PRODUCT / PROCESS CHANGE NOTIFICATION

1.1 Company		STMicroelectronics International N.V
1.2 PCN No.		MDG/20/12327
1.3 Title of PCN		AMKOR, new and additional UFDFPN8 (DFN8) assembly & test line for CMOSF8H+ Industrial Range: Additional CP 2Kbit EEPROM
1.4 Product Category		M24C02-FMC6TG M24C02-RMC6TG M34E02-FMC6TG
1.5 Issue date		2020-09-09

AMKOR, new and additional UFDFPN8 (DFN8) assembly & test line for CMOSF8H+ Industrial Range: Additional CP 2Kbit EEPROM

Back side / side views Amkor

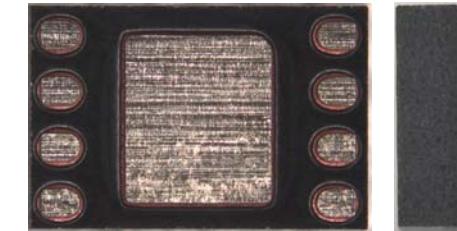
- Top side marking flanked with a vertical bar (see device marking paragraph)
- Pad shape, see below:

- UFDFPN8 (DFN8) DEVICE MARKING

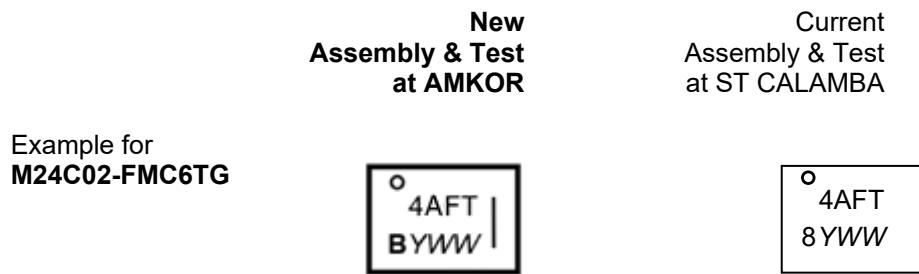
The difference is visible inside the Trace Code *PYWW* (*) where the first digit *P* for *Assembly plant* is “B” for AMKOR, this digit being “8” for current ST Calamba assembly plant.

The vertical bar denotes Amkor DFN8 with central pad compatible to ST Calamba DFN8 central pad.
